SHOP DRAWING REVIEW

PROJECT NAME: LUNENBURG	PLOT DATE: 8/6/2015
PROJECT NUMBER: NH CULV(27)	DRAWN BY: M. SMITH
FILE NAME: 11b294/cos/z11b294sub.dgn	DESIGNED BY: S. BEAUMONT
PROJECT LEADER: J. BYATT	CHECKED BY: N. CARON
SUBSTRUCTURE REINFORCING SHEET 1	SHEET 47 OF 74

CLD 12-0106 MODEL SHEET 09

MAT FOUNDATION AND PEDESTAL WALL REINFORCING PLAN
SCALE: 3/16" = 1'-0"

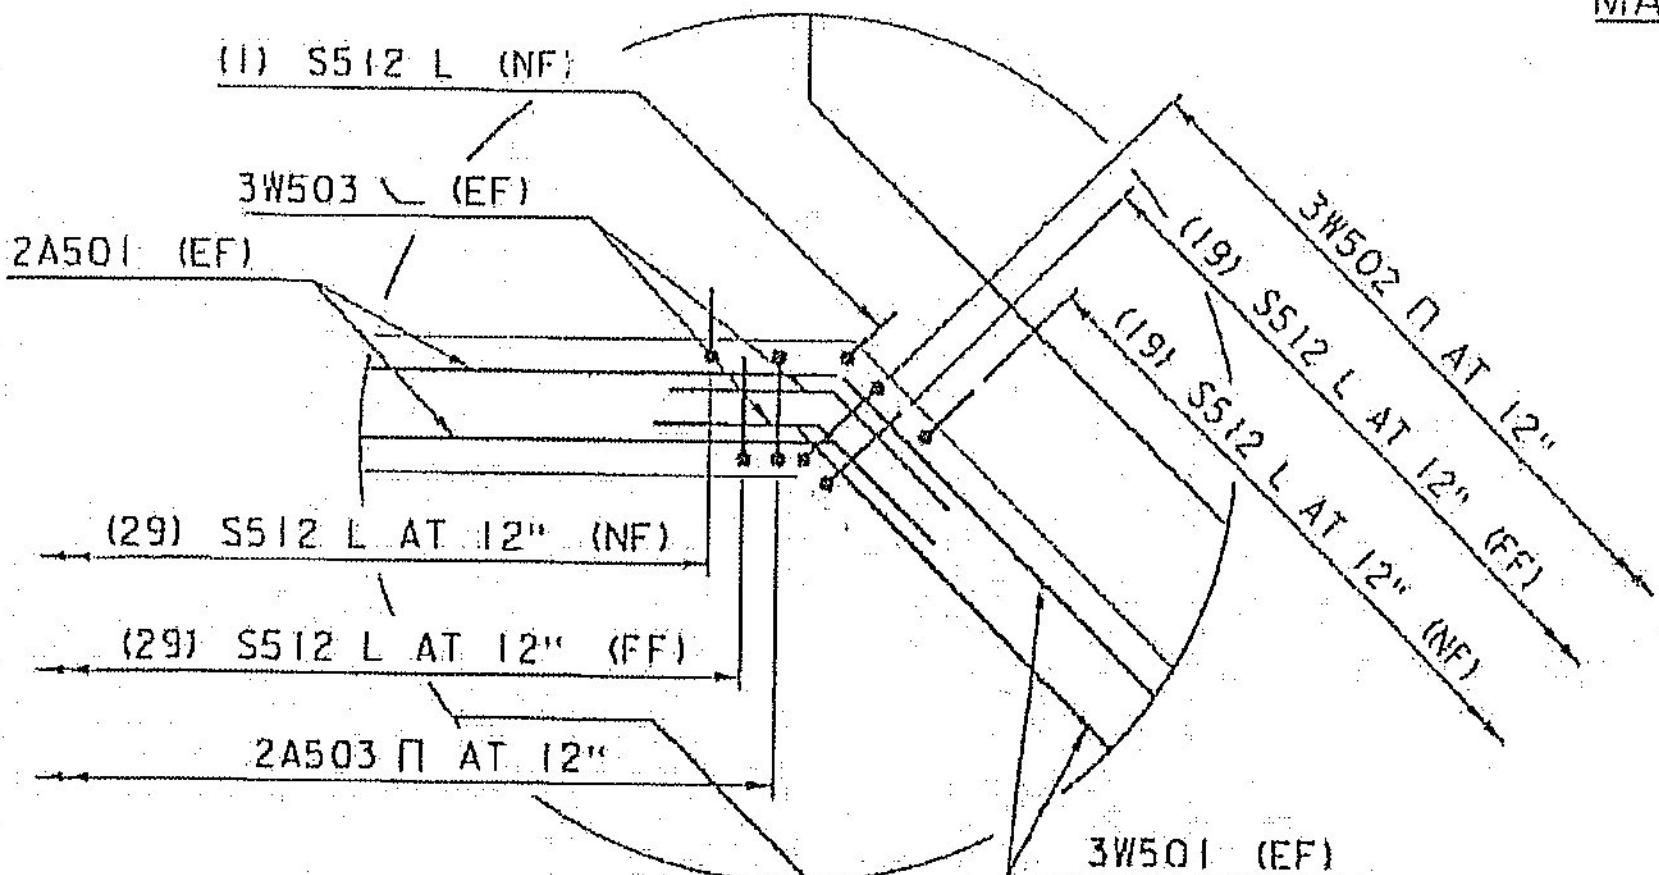
Correct, Contractor please note that rebar splice should be in Phase II pour.

*Construction Joint: Rebar overlap at construction joint is shown on wrong side of joint. See revised rebar schedule for adjusted bar lengths.
